APPENDIX 7

Supplemental Response to Comments

Attention: Alta East Wind Project
Bureau of Land Management
California Desert District
22835 Calle San Juan de Los Lagos
Moreno Valley, CA 92553

Figure 1. Proposed AEWP site from Figure 2-9 in Appendix A. Markup and comments have been added by HWI in red.

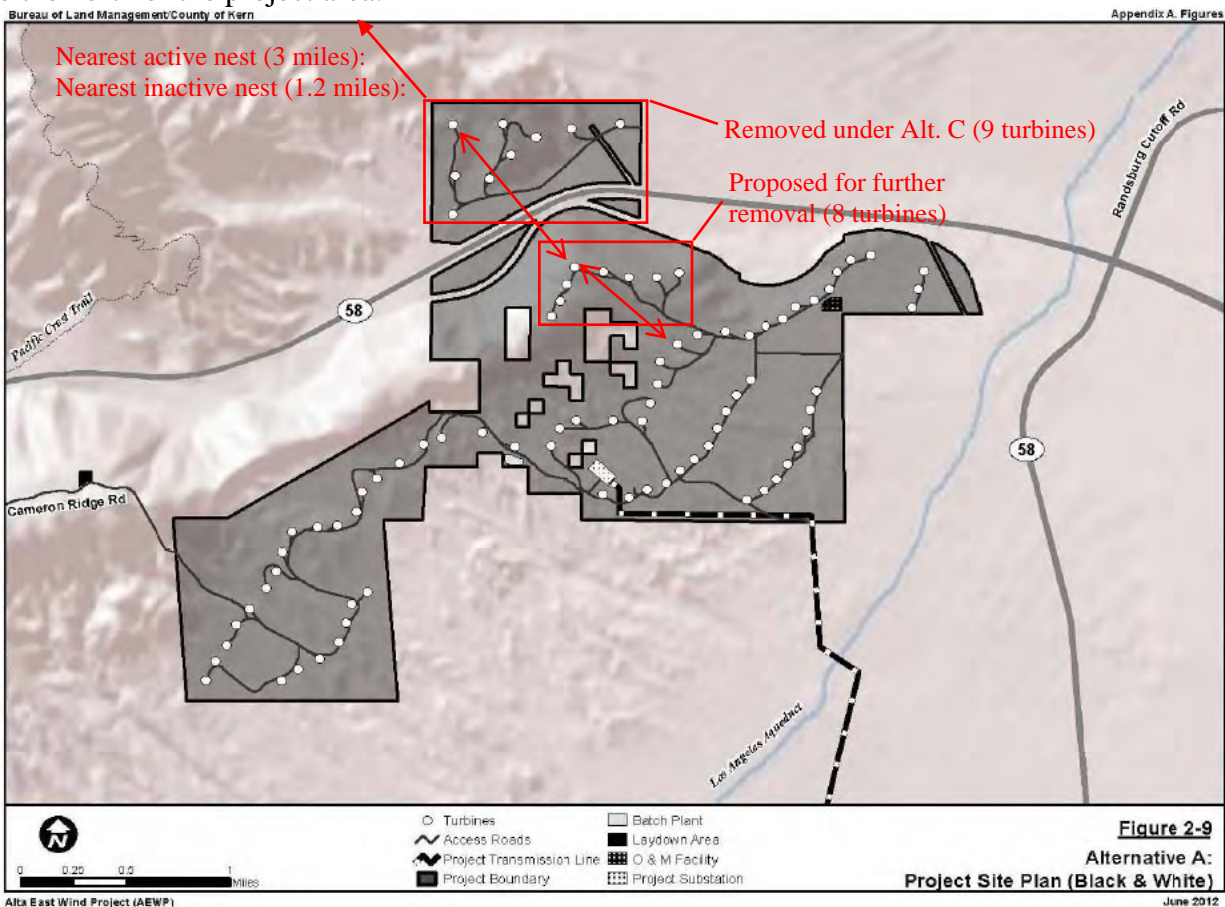
First, the Golden Eagle nesting data collected by environmental consultant WEST in 2 consecutive years suggests birds are nesting to the north of the project area in the Tehachapi Mountains (pg. 3.21-22). Appropriately, BLM is advocating for curtailment of 9 northern turbines (Alt. C). However, the increase in total nests found between the 2 years (2010: 2 active and 2 inactive; 2011: 3 active and 13 inactive; pg. 3.21-22) raises concern over the completeness of the aerial surveys. Golden Eagles often maintain multiple alternate nests in a single territory, but do not regularly build new nests (i.e., the same nests are defended for many years; Kochert et al. 2002); therefore, it is unlikely that many of the additional nests detected in 2011 were new, but more likely they were missed in 2010. It is reasonable to suspect that further survey effort would uncover additional nests. Surveys from the nearby Tehachapi Wind Resource Area suggest Golden Eagles occupy the area at moderate to high population density (pg 4.21-7). Removal of the northernmost 9 turbines under Alternate C would add provide a ~4-mile buffer between the nearest active nest and turbines and a 2.2-mile buffer from the inactive nest. Further removal of an additional 8 turbines on the ridgeline south of Hwy 58 in the central project area (see Figure 1 below) would provide an additional buffer of 0.5-mile from these active and inactive nests and any potential undiscovered Golden Eagle nests that may be present in the hills to the north of the project area.

Additional information from the AEWP PA/EIS/EIR also supports our proposed removal of additional turbines in the north-central project area (see Figure 1). A variety of raptor species are reported to have potential foraging habitat throughout the proposed AEWP. However, three species are specifically referenced in regards to attraction to the north area (see Table 3.21-1): Golden Eagles (i.e., present on site; nesting north of project area in Tehachapi Mountains; may forage throughout), Prairie Falcon (present on site; also nesting north of project area), and California Condor (high site potential; potential forage habitat in north/central portions of project area; telemetry bird recorded 4.3 miles northeast). Also, recorded flights of fall and winter observed Golden Eagles suggest most extensive use of the north and north central portions of the proposed project site (Appendix D8 [Appendices C3 and C4 within]). The existence of potential habitat for condors is a particular concern in light of their historic range and recent range expansion data that led the authors of the PA/EIS/EIR to conclude “development of a wind resource facility at this location is considered to pose a high risk of collision to this species” (pg. 4.21-22).

- 3 The commenter expresses concern regarding the completeness of golden eagle nesting aerial surveys. As noted on page 3 of Appendix D-3, *Avian Baseline Studies 2010*, and on page 4 of Appendix D-8, *Avian Baseline Studies 2011*, surveys of golden eagle nesting

sites were conducted consistent with the USFWS *Interim Golden Eagle Technical Guidance: Inventory and Monitoring Protocols; and other Recommendations in Support of Golden Eagle Management and Permit Issuance* (2010). The commenter states that removal of an additional 8 turbines from the project on the ridgeline south of Highway 58 would provide an additional buffer of 0.5-mile from active and inactive golden eagle nests. The comment is noted.

The BLM has considered the best available information in the analysis of operational impacts to golden eagle and determined that the biological survey data documented in Appendices D-3 through D-8 of the Draft EIS/EIR was adequate to assess bird use at specific locations within the project area. As illustrated in the Appendices, fixed-point bird use survey points were distributed throughout and adjacent to the AEWP site and provide adequate coverage of the site. Alternative C was developed to eliminate wind development in this portion of the project area in order to minimize impacts to golden eagle. The Applicant submitted an application for an eagle take permit on March 4, 2013, and is developing an Eagle Conservation Plan as a component of this process. A draft version of the Eagle Conservation Plan was included in Appendix D-30 of the Draft EIS/EIR. Please also see Response to Comment 2.

- 4 The commenter cites information in Draft EIS/EIR Table 3.21-1, *Special-Status Animals Present or With Potential to Occur at the AEWP Site*, regarding golden eagle, prairie falcon, and California condor (including foraging habitat, presence on-site, and nesting locations) as additional support for the commenter's proposed removal of 8 turbines from the project. The comment is noted. Please see Response to Comment 3.
